SAN FRANCISCO MARINA RENOVATION PROJECT

Final Environmental Impact Report

San Francisco Planning Department
Case No. 2002.1129E
State Clearing House No. 2003122131

Figure 3
Proposed Site Plan

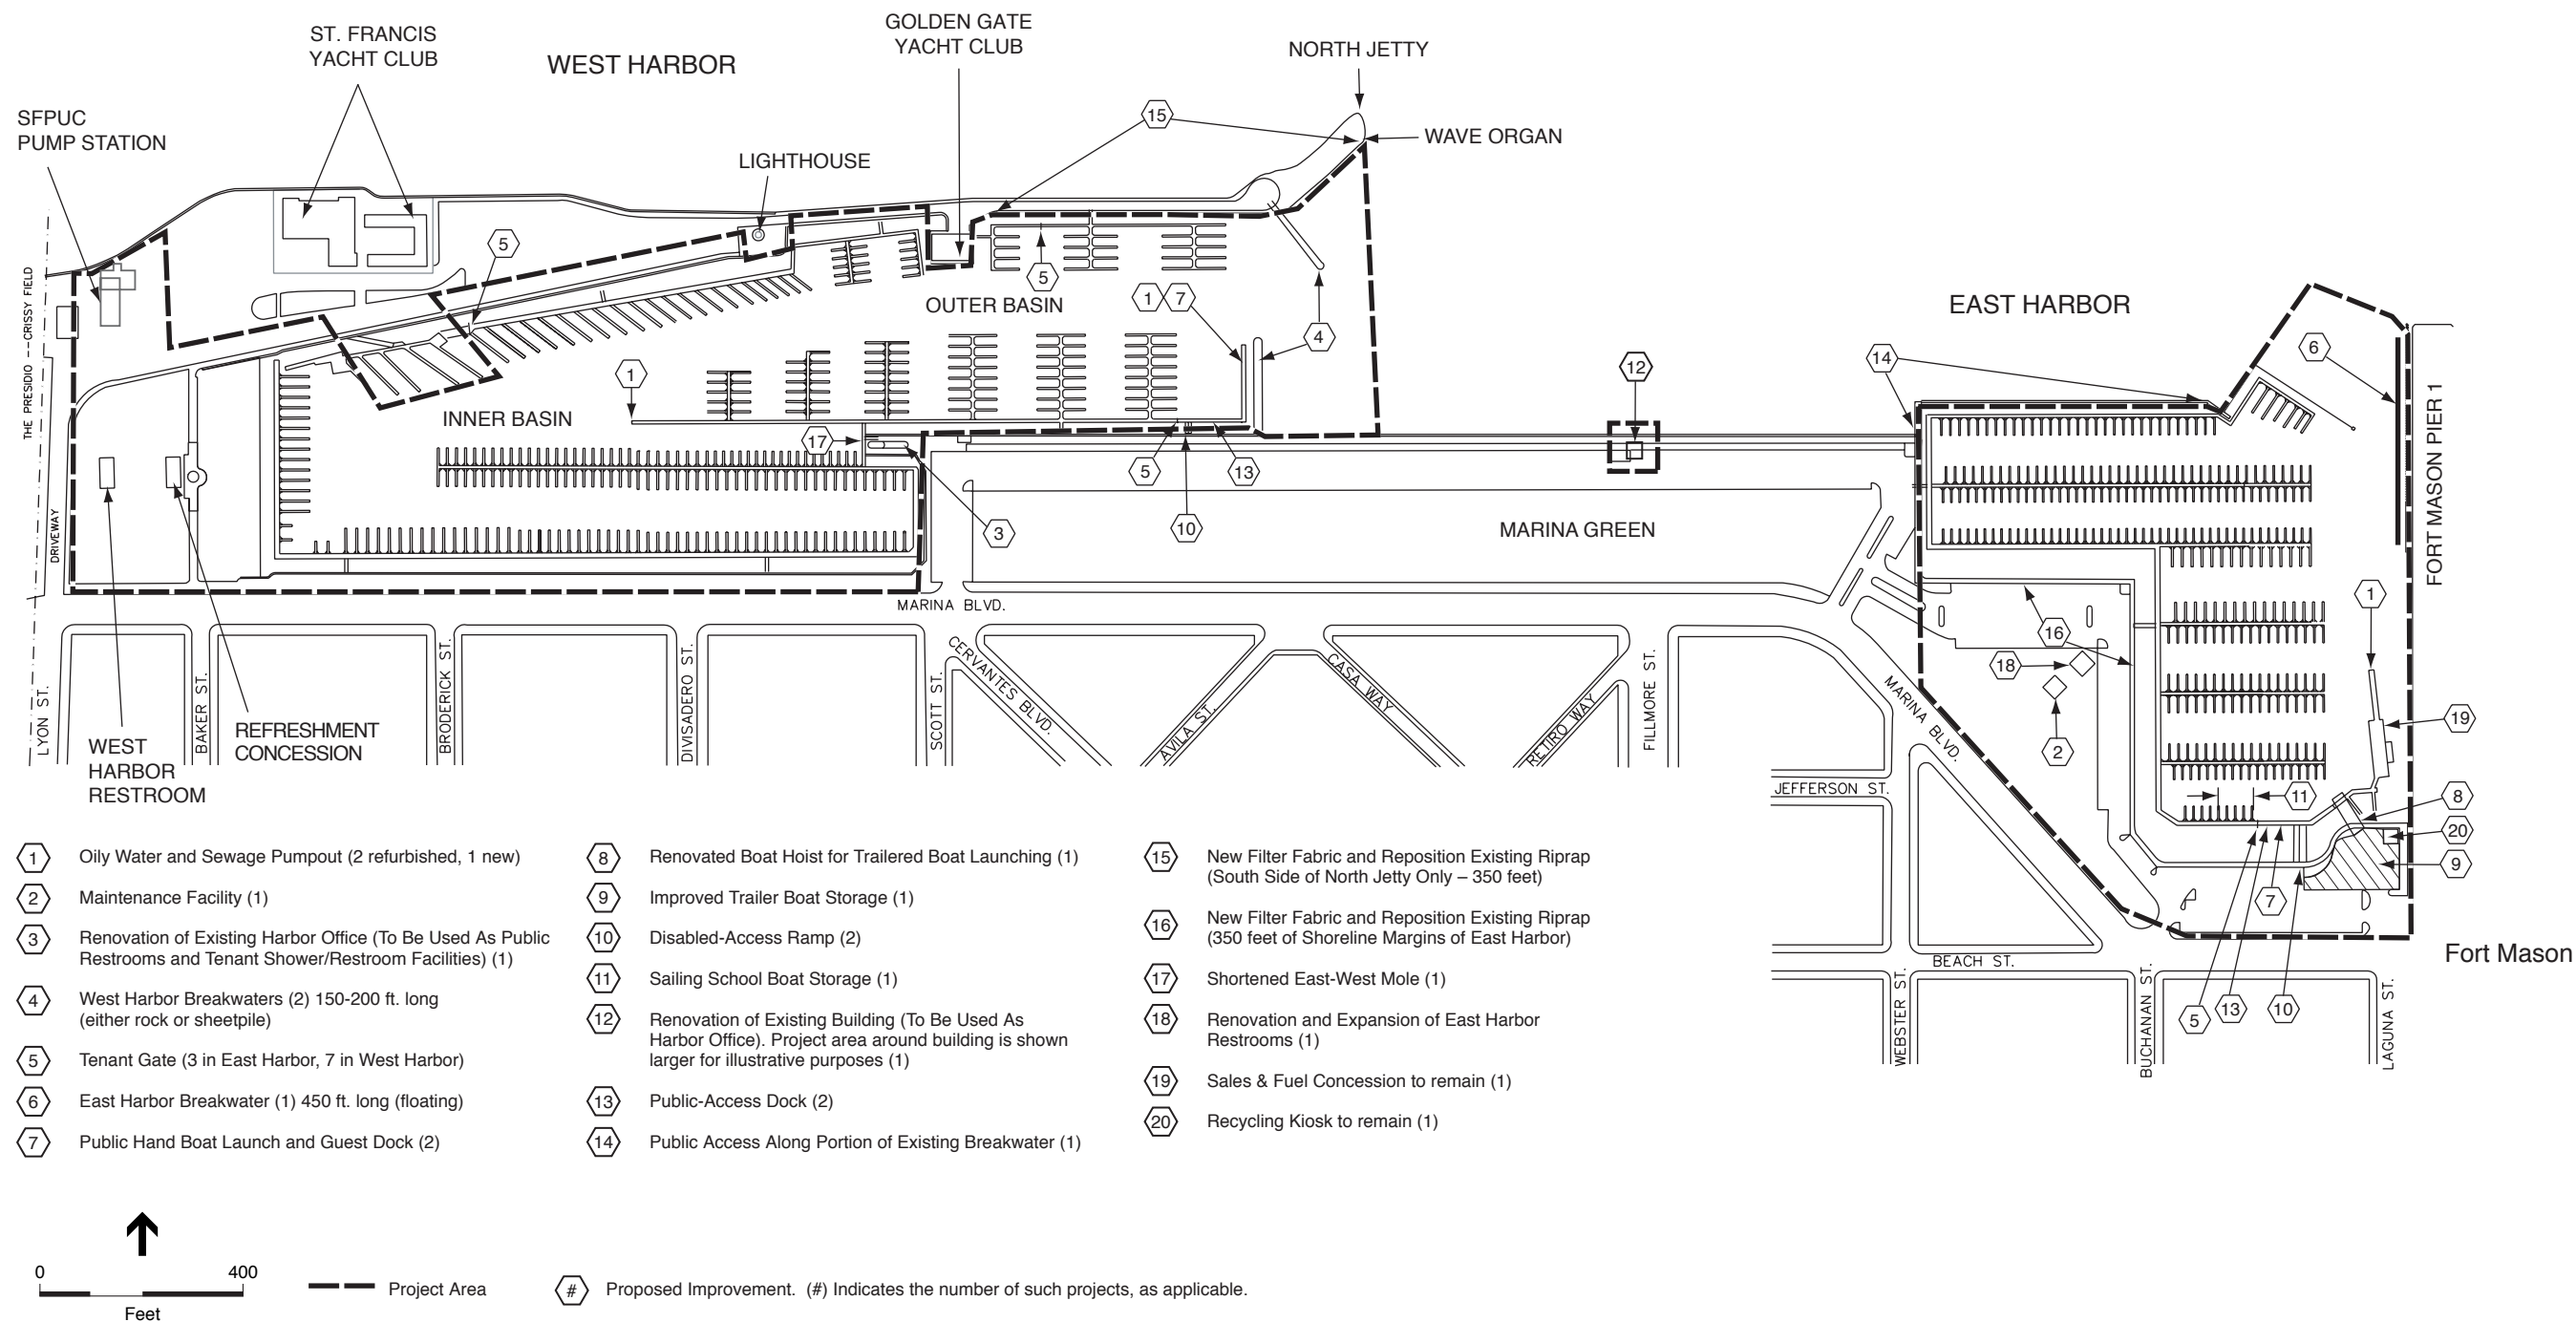
If for some reason that has not been articulated in the Draft EIR, the proposed building is necessary, it could be located north of the public restrooms at the West Harbor near the SFPUC Pump Station. See Figure 3 at II-7. That location abuts an existing driveway and would not block any views nor interfere with recreational use of the surrounding space. This alternative should also be considered.

Figure 3, *Proposed Site Plan*, on DEIR page II-7, identifies the area of the renovated boat hoist and boat trailer storage area (items #8 and #9 on the figure), and the public hand boat launches and guest docks (item #7 on the figure) shown in both the East and West Harbors.

Figure 3, *Project Site Plan*, on page II-7 of the DEIR graphically illustrates the project area as a dashed line, to define the limits of construction of the proposed project, which are generally confined to the East and West Harbors of the marina and exclude the Marina Green. One project component that is located near the Marina Green is the Degaussing Station, proposed for reuse as a Harbor Office. A dashed line is shown around this building indicating that it too would be within the project area boundaries. Although most of the construction work would be on the interior of this building, a smaller project area boundary would not have been readable at the figure scale provided. Therefore, a somewhat larger project area 'box' was drawn around this building. As noted on item #12 on Figure 3, "Project area around building is shown larger for illustrative purposes."

Figure 6
Existing and Proposed Views
from Viewpoint Location 2

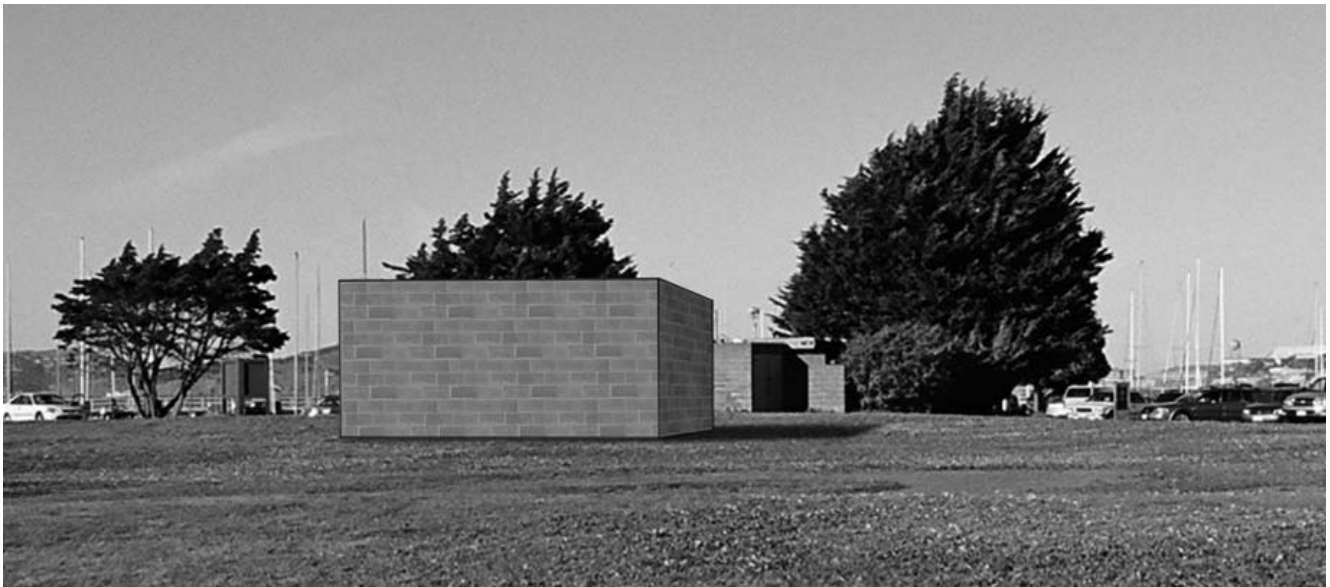
If one picture is better than a thousand words, Figure 6 on p. III.B-9 says it all. Clearly the proposed maintenance building sited virtually in the middle of the East Harbor open space dominates the space. From almost any angle on Marina Blvd. between Webster and Buchanan streets the proposed building blocks views of trees, water and distant vistas. It would stand out like a sore thumb. This happens because the proposed building is sited close to the middle of the space.

DEIR page III.B-9, Figure 6B, provides a visual simulation of the proposed maintenance building in the East Harbor open space area. As this simulation shows, the proposed building would be located on a site where views of the boats and distant hills are obstructed by the restroom building and trees. DEIR page III.B-8 states, “the proposed location of the maintenance building in front of tall trees and adjacent to existing structures would not substantially degrade or obstruct any scenic view now observed from public viewpoints. The view is partially obstructed under existing conditions, and under project conditions the trees and other buildings adjacent to the maintenance building would continue to obstruct views of Tiburon and the Marin Headlands in the distance, though the view blockage would be slightly greater due to the new maintenance building. The existing marina facilities would continue to be visible under the proposed project.” While views of trees may be preferable to views of a building, views from this area looking toward the Bay are partially obstructed under existing conditions. The proposed building is therefore not blocking an existing view or degrading the overall visual character of the marina setting. Therefore, the DEIR appropriately concludes that, “Although visual quality is subjective, it can reasonably be concluded that the proposed project would not result in a substantial, demonstrable negative aesthetic effect on the visual character or quality of the area and its surroundings.”

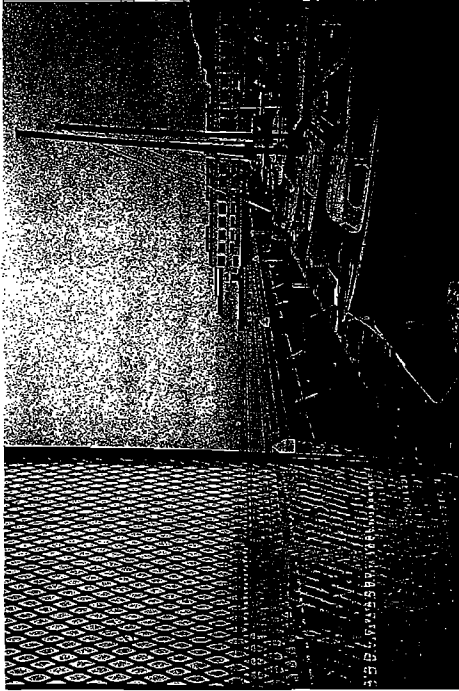
Photo of the East Harbor Sheetpile breakwater that is proposed to have new public access. While the photo-simulation of the West Harbor breakwater is a rip rap material, the project sponsor may elect for the West Harbor Breakwater to be this sheetpile material.
